HLWYM HEmails

From: Xihua He
Sent: Thursday, March 09, 2006 6:22 PM
To: David Pickett
Subject: RE: More questions on carbon steel experiments

-----Original Message-----
From: David Pickett [mailto:dpickett@cnwra.swri.edu]
Sent: Thursday, March 09, 2006 3:35 PM
To: Xihua He
Subject: More questions on carbon steel experiments

XRDSpecimen.jpg

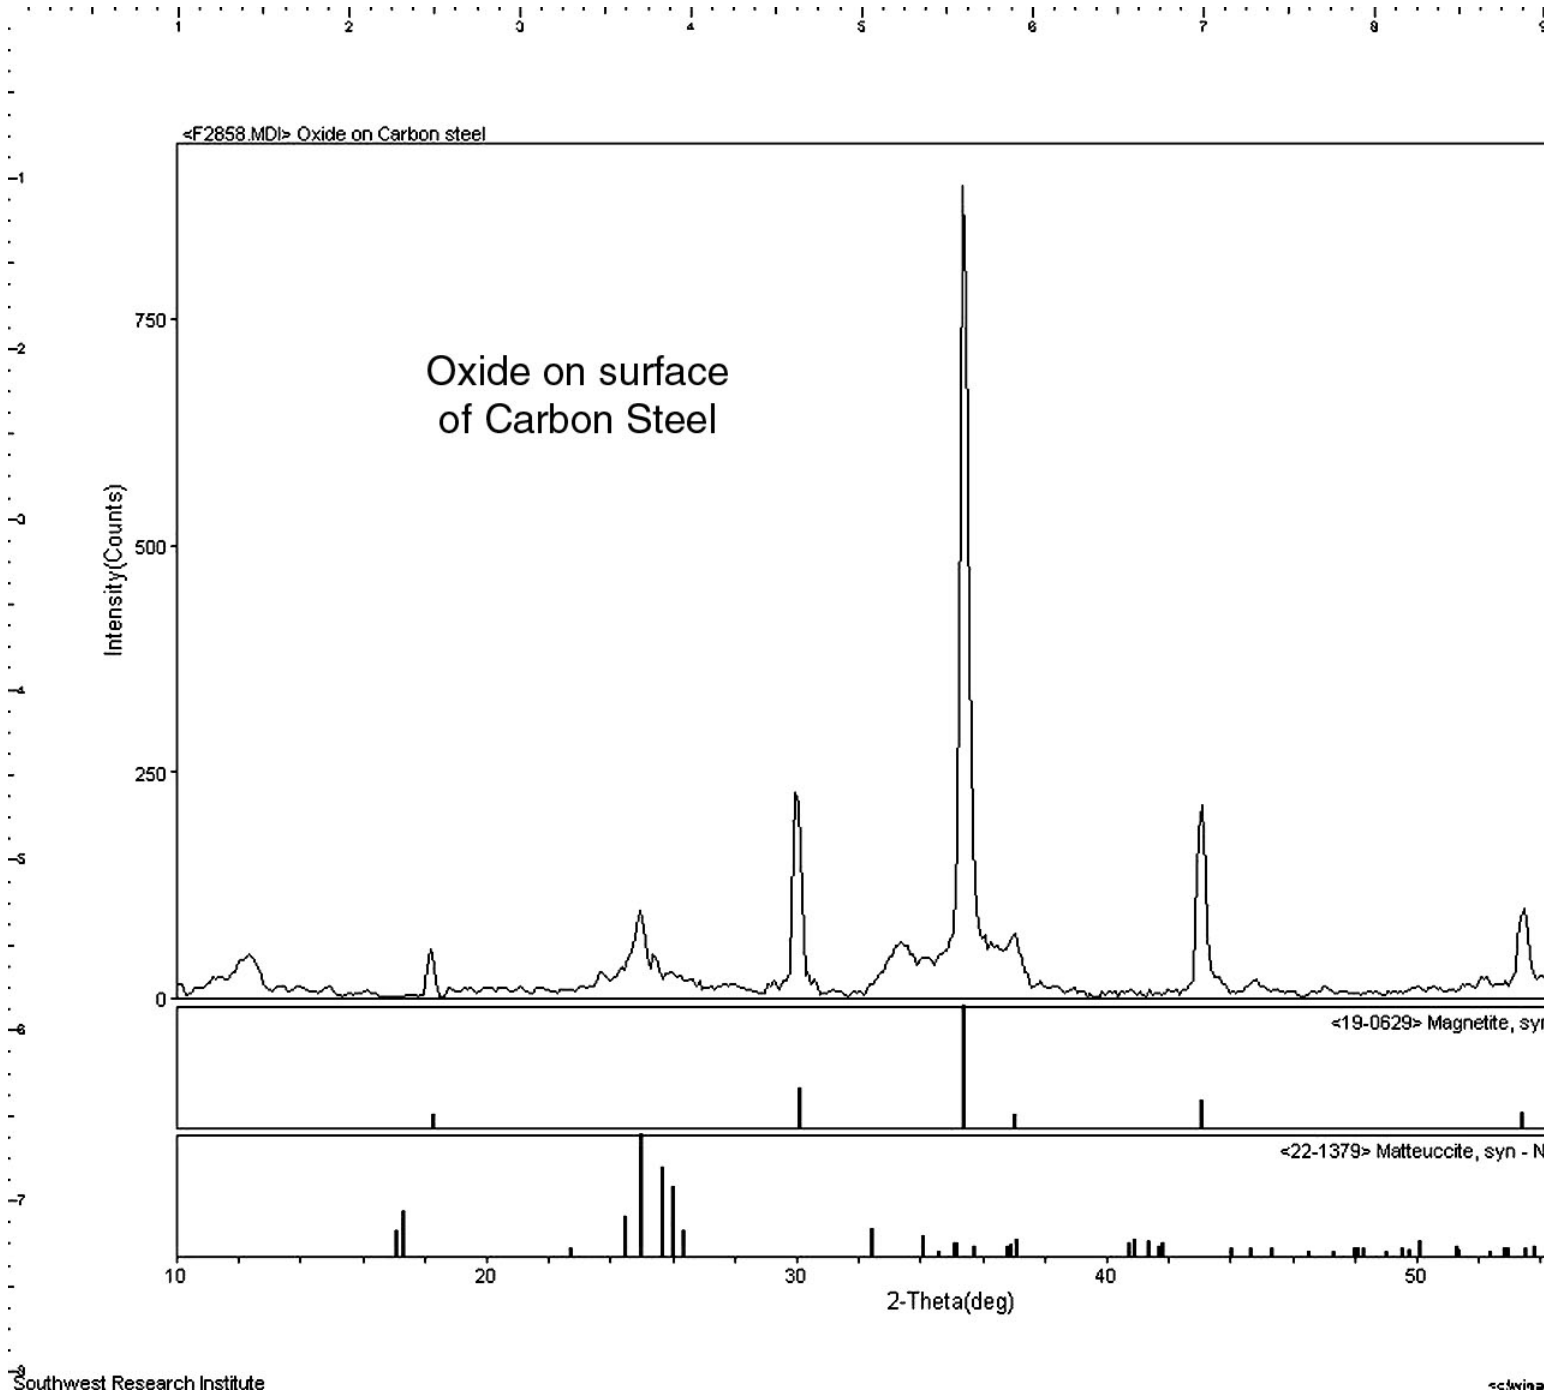
Do you yet have any solid phase identification data?

4. I did XRD analysis for the corrosion product, which is mainly magnetite. The XRD results are attached.
